PROJECT:	Durham Meadows Waterline Remedial Design		
CONTRACT NO.:	W912WJ19C0002	AECOM PROJECT NO.:	60494812
ENGINEER'S SUBMITTAL NO.:	02160-1	REVISION IDENTIFIER:	1
CONTRACTOR'S SUBMITTAL NO.:	02160-1	REVISION IDENTIFIER:	1
SUBJECT:	Excavation Support Systems		
REVIEW CODES:			
<p>A – Approved as submitted. B – Approved, except as noted on drawings. C – Approved, except as noted on drawings. Refer to attached comments. Resubmission required.</p> <p>D – Will be returned by separate correspondence. E – Disapproved. Refer to attached comments. F – Receipt Acknowledged.</p> <p>X – Receipt acknowledged, does not comply with contract requirements, as noted. G – Other action required.</p>			
The Engineer's review is for general conformance with the design concept and Contract Documents. Markings or comments shall not be construed as relieving the Contractor from compliance with the Contract plans and specifications or from departures there from. The Contractor remains responsible for details and accuracy, for confirming and correlating all quantities and dimensions, for selecting fabrication processes, for techniques of assembly, and for performing work in a safe manner. AECOM Technical S

TRENCH SHIELD DIAGRAM

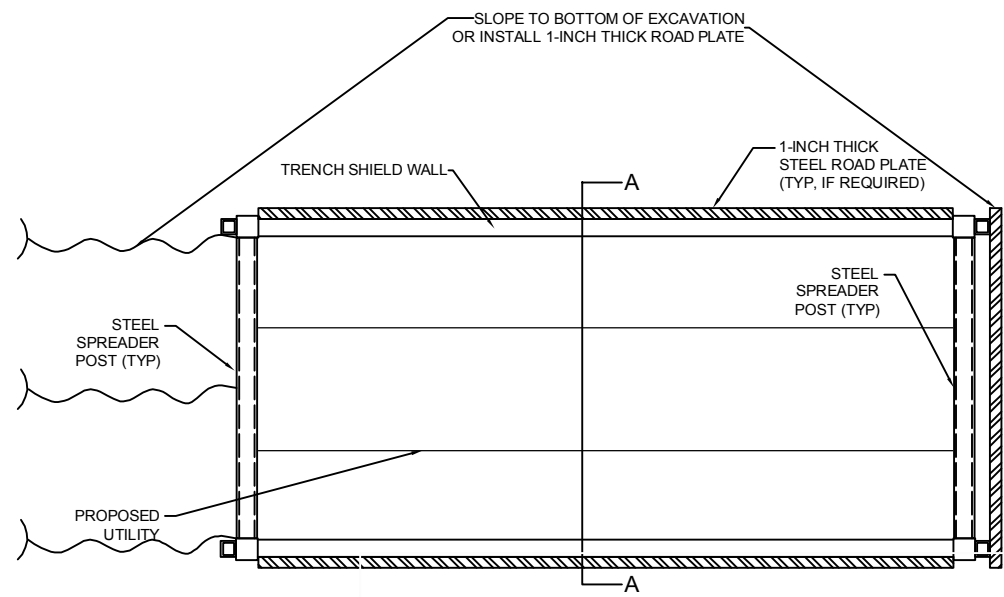
COMMENT NUMBER	REFERENCE	CODE	COMMENT
1.	02160 1.03 2	C	<i>Provide site specific excavation support plans for altitude valve vault, water meter vault, pressure reducing vault, stream crossings, and pipe casing installations in addition to the trench support plans.</i> Resubmittal indicates this will be provided in future. Submittal reviewed for trench operations only.
2.	02160 1.03 2	B	Provide minimum lateral distance from excavation support for vehicles, construction equipment, and stockpiled construction and excavation materials. Distance provided.
3.	02160 1.03 3	B	Provide construction contingency plan. Not provided See note 16 on Exhibit A-1
4.	02160 1.05	B	Provide maximum width of pipe trench supported. Not provided. See note 13 on Exhibit A-1

13. WIDTH OF TRENCHES TO BE SUPPORTED SHALL BE LIMITED TO THE MANUFACTURED TRENCH SHIELD SPREADER LENGTH.
14. CONSTRUCTION EQUIPMENT SHOULD NOT BE LEANED AGAINST OR SUSPENDED FROM TRENCH SHIELD SPREADERS AT ANY TIME.
